National Dam Inspection Program. Locust Lake Dam (NDS-ID-PA-00666, DER-ID-54-164) Delaware River Basin, Locust Creek, Schuylkill County, Pennsylvania. Phase I Inspection Report.

LOCUST LAKE DAM

PHASE I INSPECTION REPORT

A. Upstream Slope of Embankment.
View from Spillway Approach Channel.

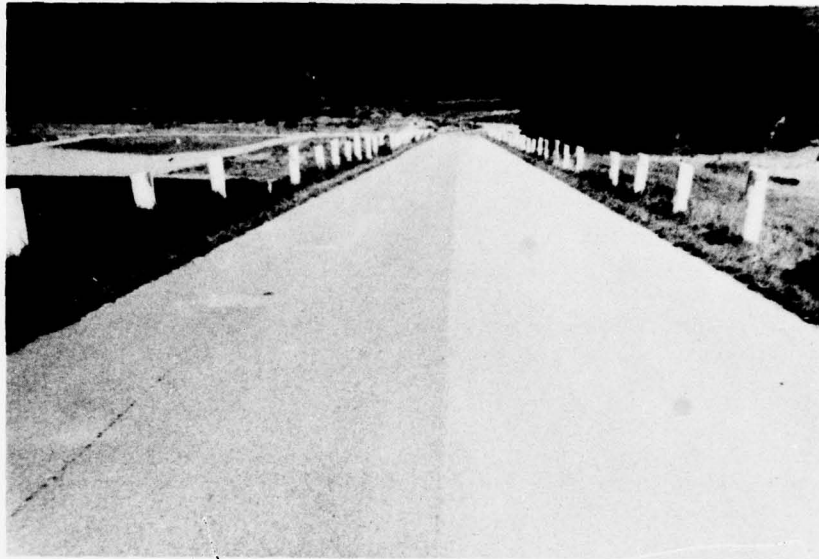
(2) There is some concern for the fact that the riprap on the upstream face does not extend to the top of the embankment. General practice is to provide upstream slope protection from the top of the dam to a safe distance below normal pool level. The unprotected portion of the upstream slope could be eroded by wave action during a flood condition.

(2) Upstream Slope. It was observed that the riprap does not extend to the dam crest. The detailed description and evaluation of the condition are in Paragraphs 3.1b. and 3.2a.(2), respectively.

(1) Raise the riprap on the upstream slope of the embankment to the top of dam elevation.

F. Wet Area at the Downstream Toe of Embankment.

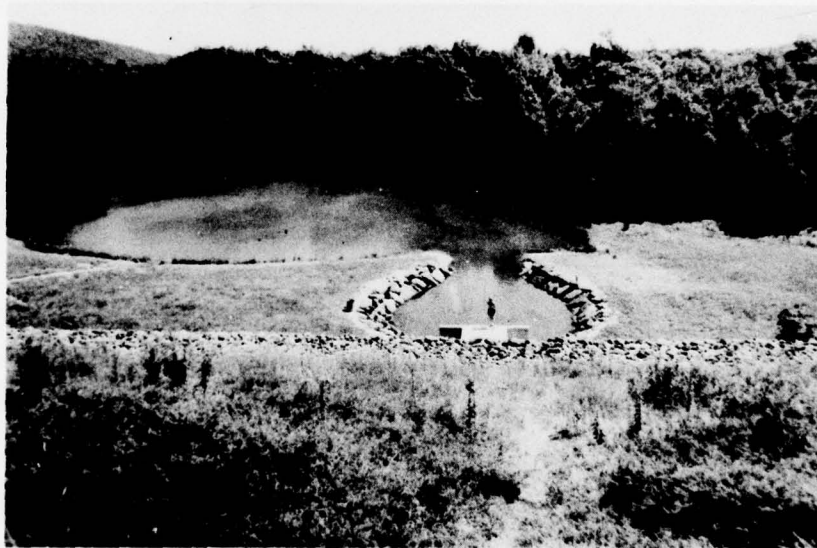
(3) There is some concern for the wet area at the downstream toe of the embankment. Wet areas were first observed near the toe in 1972, and the drainage ditch system described in Paragraph 2.1b. was built to provide an outlet for the wet areas. Control of the wet area by the drainage ditch system is satisfactory. The general area is being monitored by the park forces.

(3) Downstream Slope. A wet area was located along the toe of the embankment. The detailed description and evaluation of the condition are in Paragraphs 3.1b. and 3.2a.(3), respectively.

(1) Install two or more observation wells, or other instrumentation, downstream from the axis of the dam. The instrumentation should be located in the vicinity of the wet area at the toe of the embankment to determine the water level in the downstream embankment. Periodically monitor and record the water levels and continue to observe the wet area so that any change in conditions is apparent.

K. Intake Structure and Staff Gage.

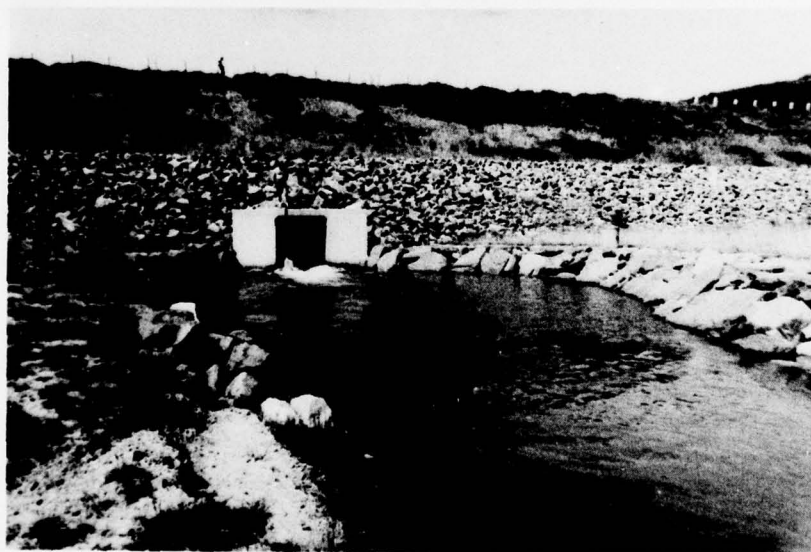
(2) There is slight concern for the two cracks on the intake structure. The cracks are relatively small, and the integrity of the intake structure is not in question. Because the air vent on the intake structure would be submerged at maximum pool level, the ultimate capacity of the outlet works is uncertain. In addition, debris could cause significant blockage of the intake structure and greatly reduce the outlet works capacity.

(3) Visually monitor the two small cracks on the intake structure deck. Also, visually monitor the fine crack in the right wall of the outlet conduit. If changes are noted, take appropriate action.
